Official Transcript of Proceedings NUCLEAR REGULATORY COMMISSION

Title: Advisory Committee on Reactor Safeguards

Date: Wednesday, November 2, 2022

the 10 CFR Part 53, which would be a new alternative risk-informed, performance-based and technology-inclusive framework for the licensing and regulation of commercial nuclear power plants.

Why Revise the AERI Entry Conditions?

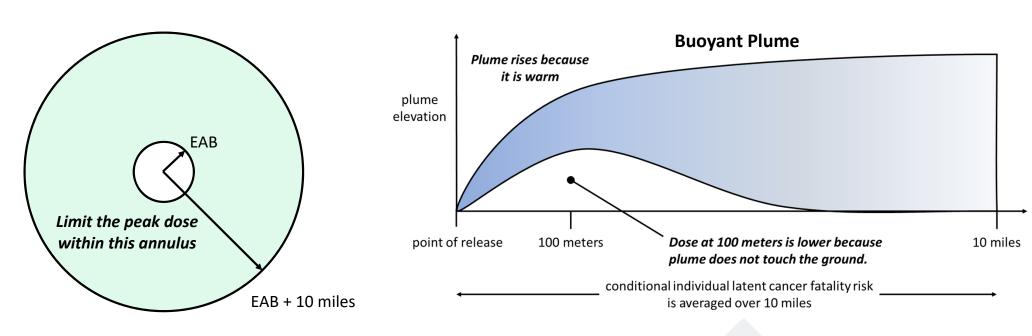
With that, next slide. Why did we actually revise the entry conditions? Well, some stakeholders commented that the current ones, the ones that we presented at the subcommittee meeting, were overly conservative.

- Some stakeholders have commented that the current proposed AERI entry conditions are overly conservative.
- MACCS scoping calculations indicate that dose at 100 meters is an inadequate predictor of conditional risk. Depending on the assumptions (e.g., plume elevation or buoyancy), some conditional risks may be below the QHOs while others may be above the QHOs even though the current AERI entry condition is met.
- Provide increased flexibility when determining if the AERI entry conditions are met.

Revised AERI Entry Conditions

• The change from dose at 100 meters to the peak dose within the 10-mile annulus addresses concerns about elevated releases and plume buoyancy.
